GROUP 16

ENGINE ELECTRICAL

IGNITION SYSTEM

OUTLINE OF CHANGE

CRANK ANGLE SENSOR <4G9>

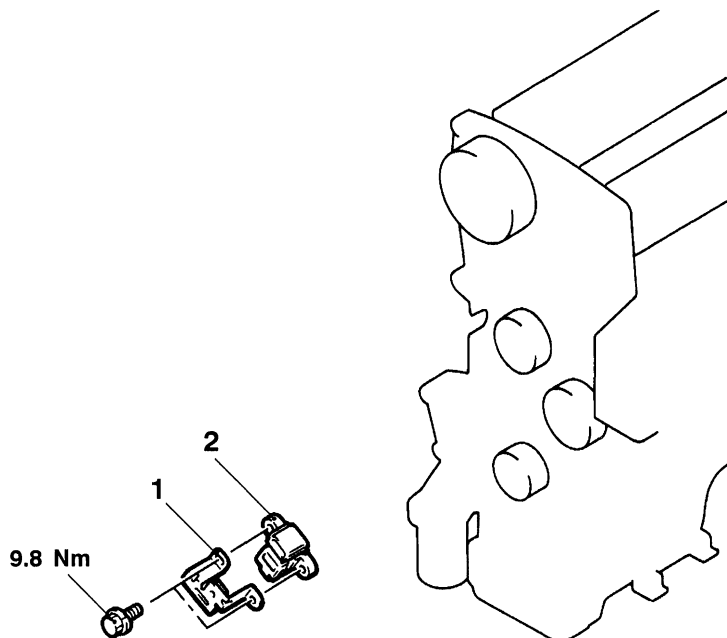
The crank angle sensor for the 4G9 engine has been changed.
